Subject: **PALO VERDE SOLAR 1, LLC'S INITIAL COMMENTS ON THE STAFF
ASSESSMENT/DRAFT ENVIRONMENTAL IMPACT STATEMENT
DOCKET NO. (09-AFC-6)**

Application for Certification for the
BLYTHE SOLAR POWER PROJECT

DOCKET NO. 09-AFC-6

**PALO VERDE SOLAR 1, LLC'S INITIAL
COMMENTS ON THE STAFF
ASSESSMENT/DRAFT
ENVIRONMENTAL IMPACT
STATEMENT**

Soil and Water
Figure 10
Northern Transect
Fluoride in Groundwater -
Mesa vs. Floodplain

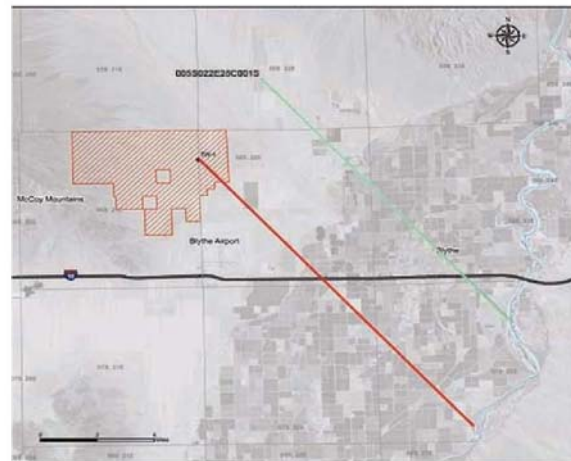
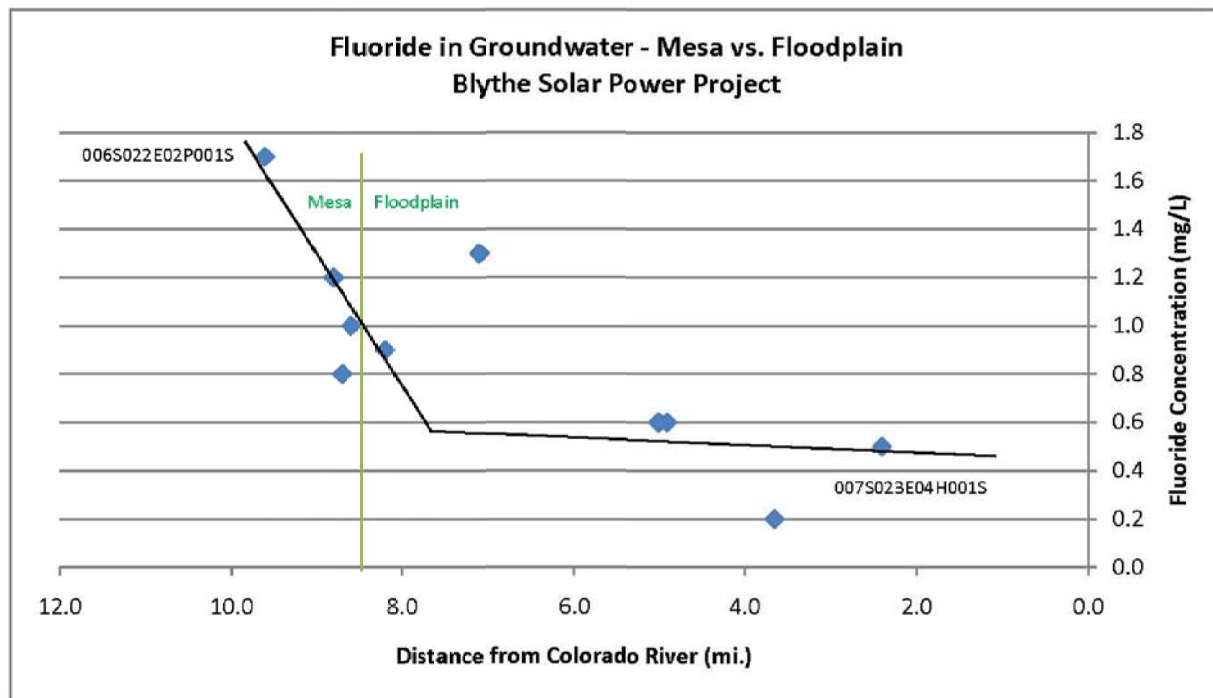
Soil and Water - Figures -7 through 13, are transects for two locations from the river and area north of the Project site and through the Project site. The graphs illustrate TDS, chloride, boron and fluoride concentrations with increasing distance away from the Colorado River. They provide additional data showing the changes in water chemistry, and thus water sources for the flood plain and the mesa.

PLOT PLAN
AIR COOLED CONDENSER OPTION

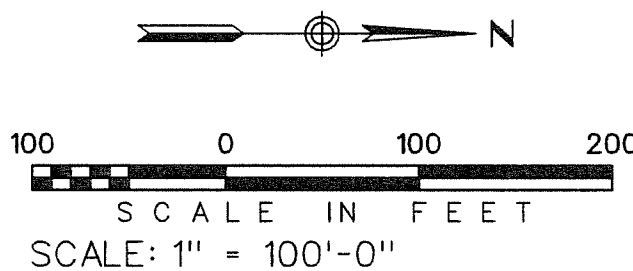
These changes are reflected in the attached drawing 2008-045E-PP-001ALT, Plot Plan, Air Cooled Condenser Option for a revised plot plan and power block layout.
